DCEM 1.3

Nov 29nd, 2023

Dante Totani

“Final” configuration:

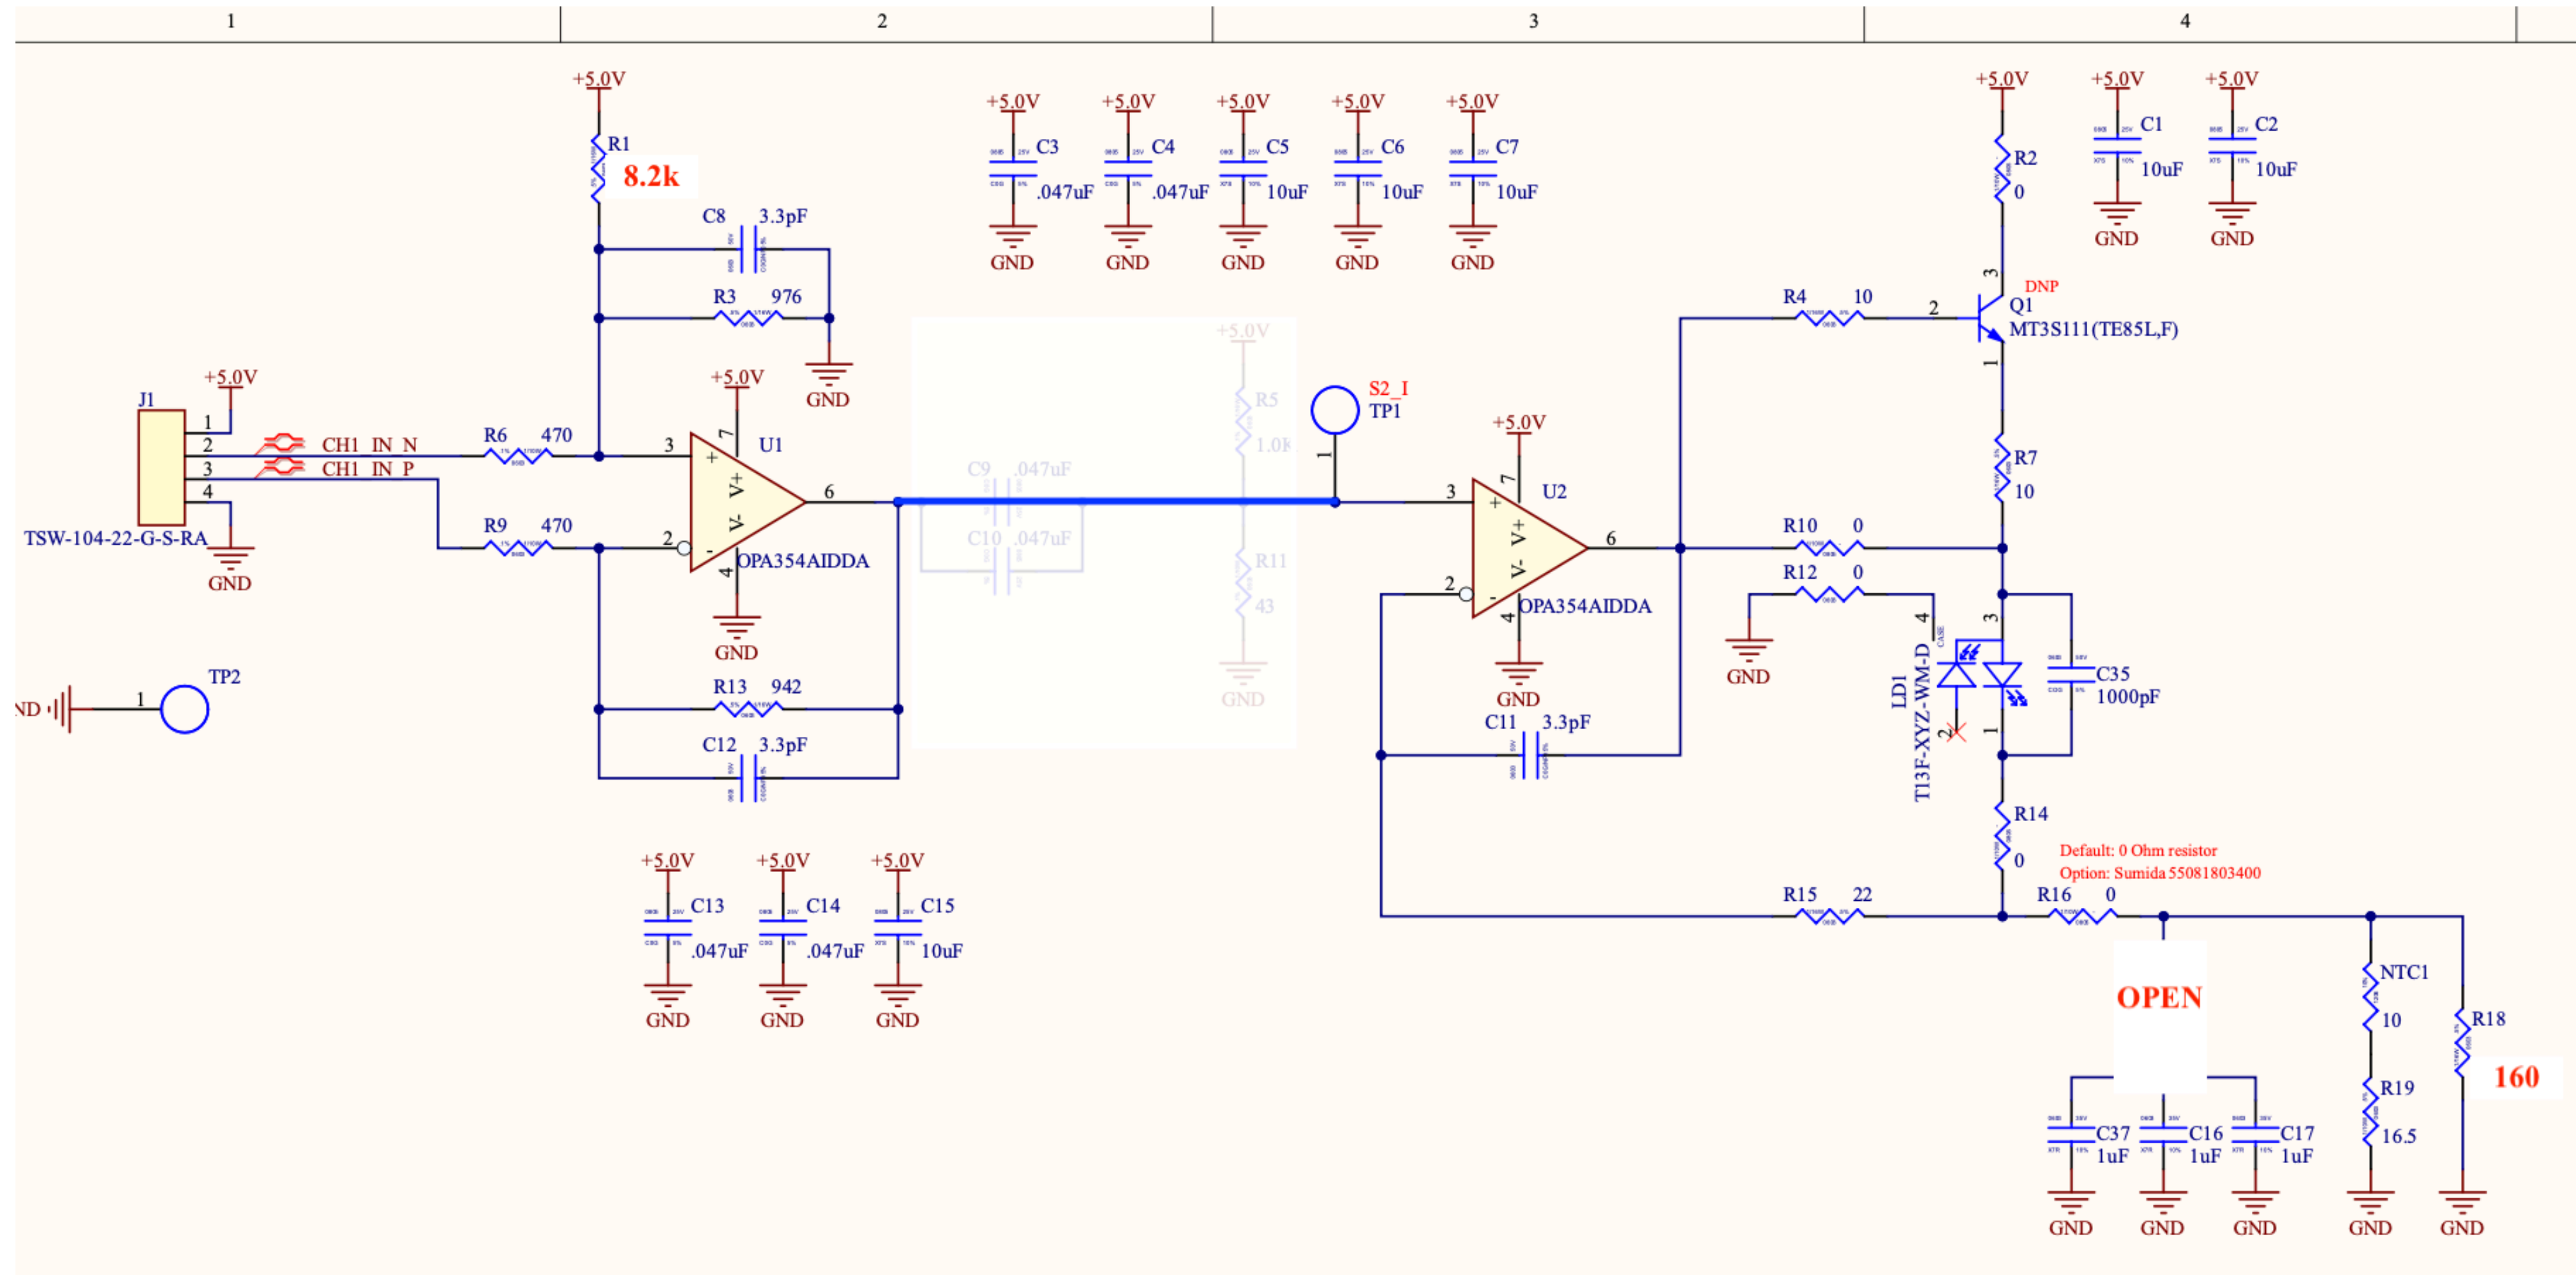
Laser Output Load: R18 = 160 Ohm (only DC)

Offset 2nd OpAmp in: R1 = 8.2k Ohm

$$V_{offset} = 414.2 mV$$

$$I_{laser} = 2.589 mA$$

Channel 1

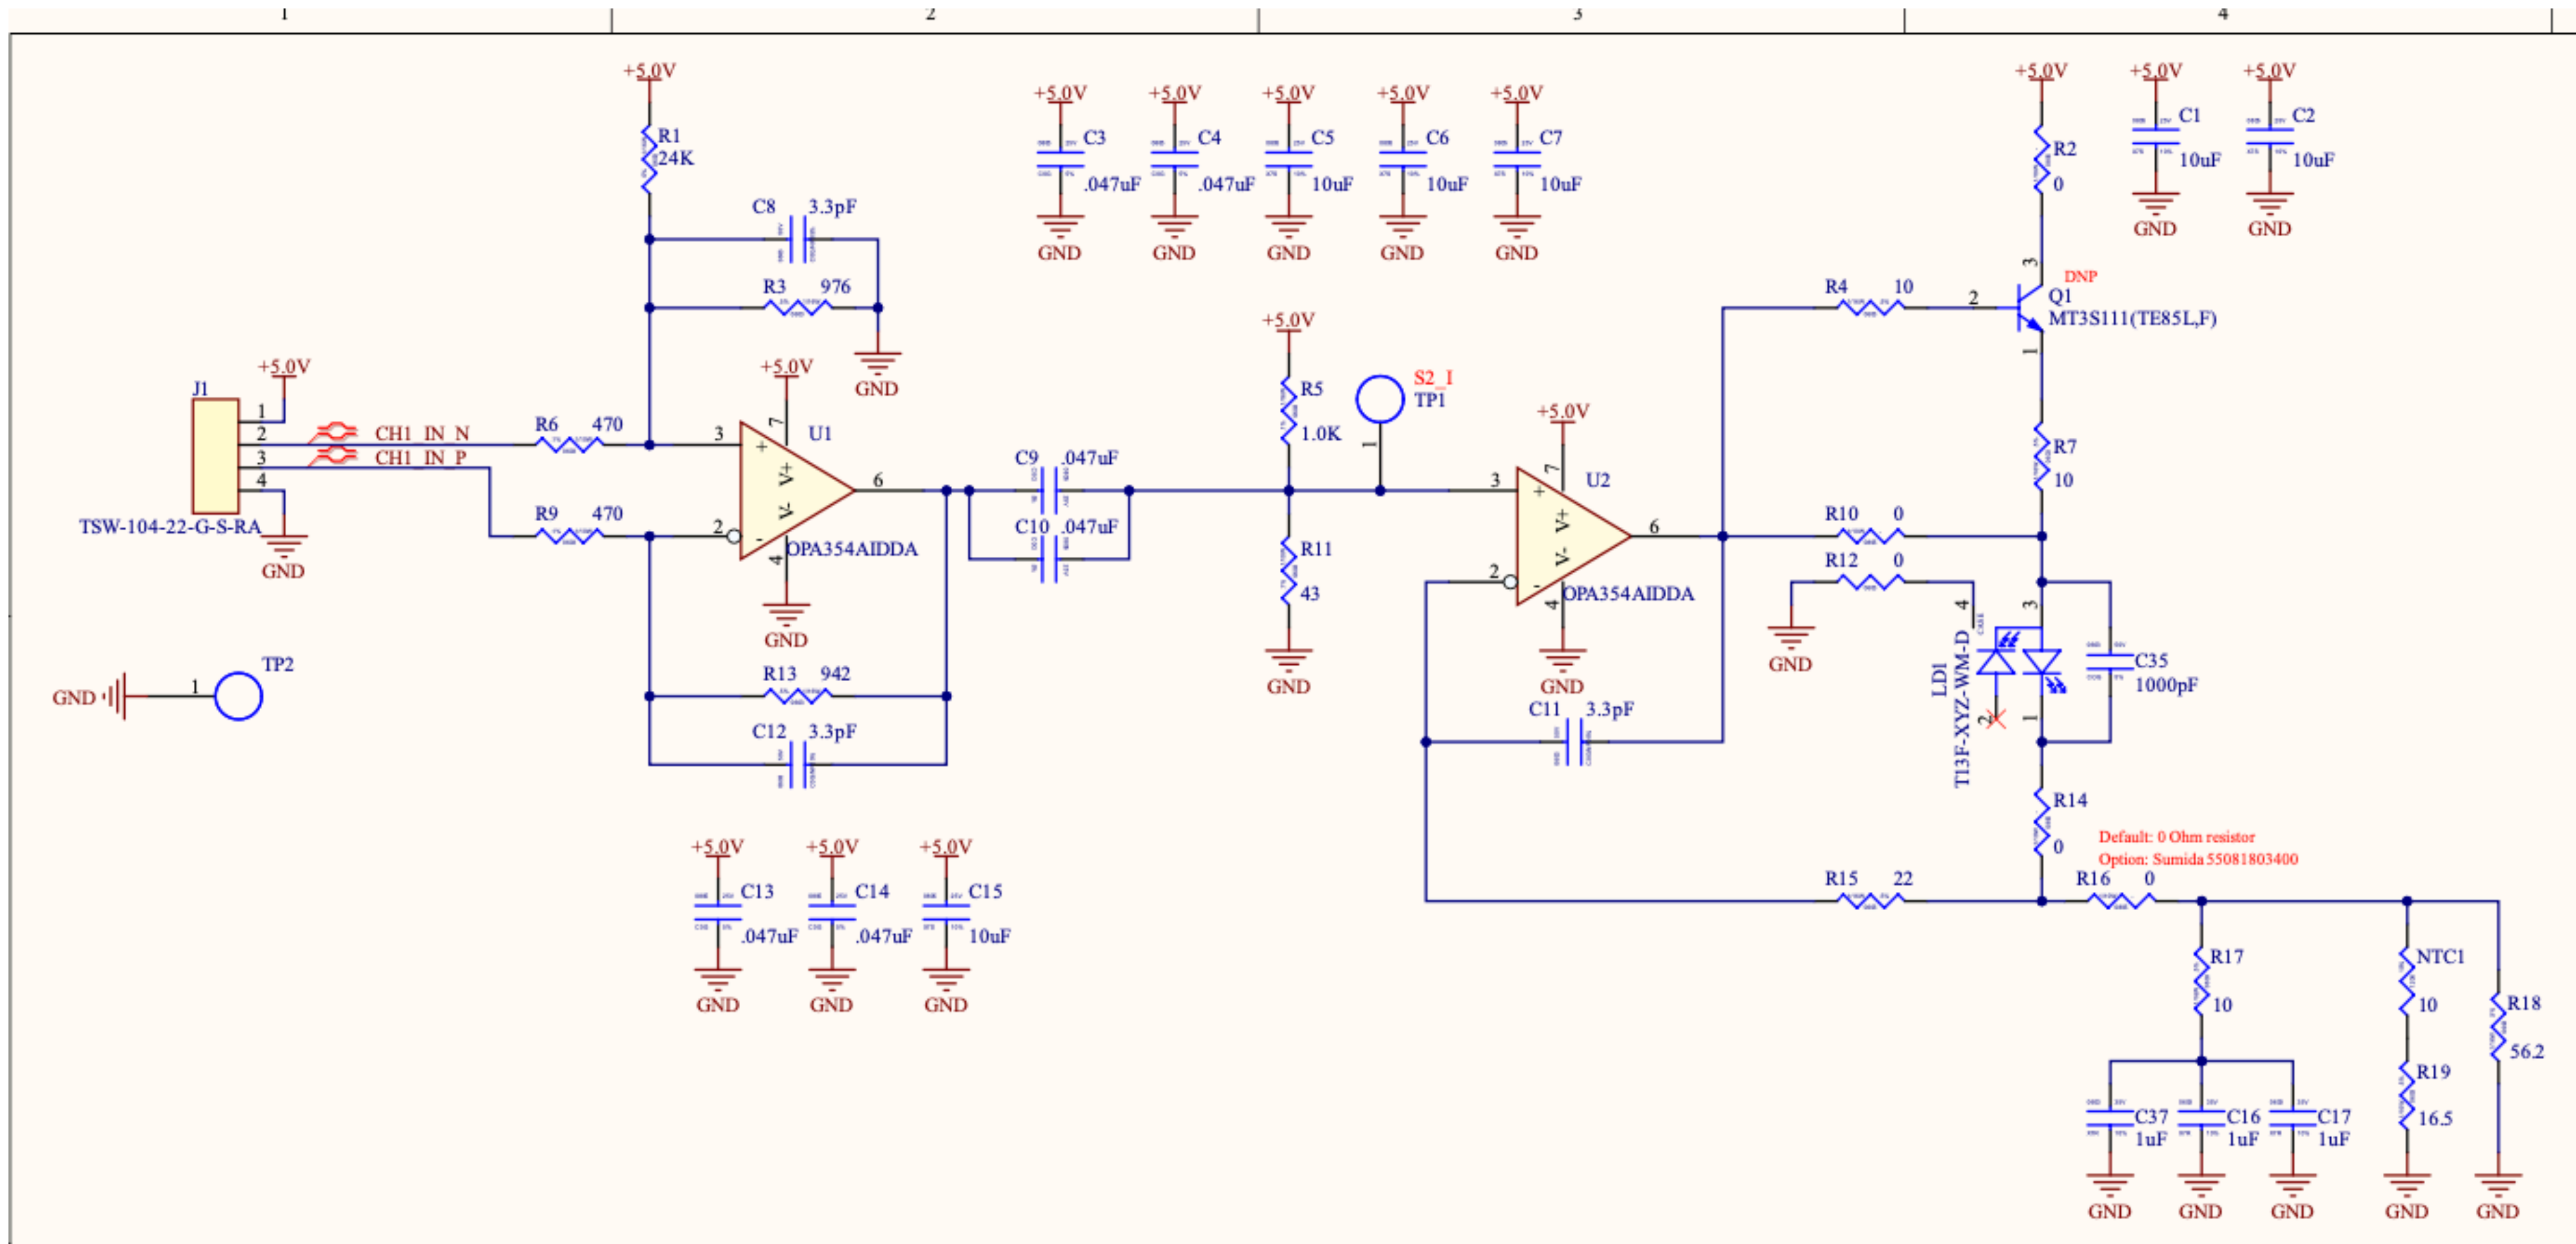
List of changes

- R1, R20 -> replace with 8.2 k Ω
- R18, R37 -> replace with 160 Ω
- R5, R11, R17, R24, R30, R36 -> remove
- C9, C10, C26, C27 -> remove and jumper (0 Ω) on C9 and C26
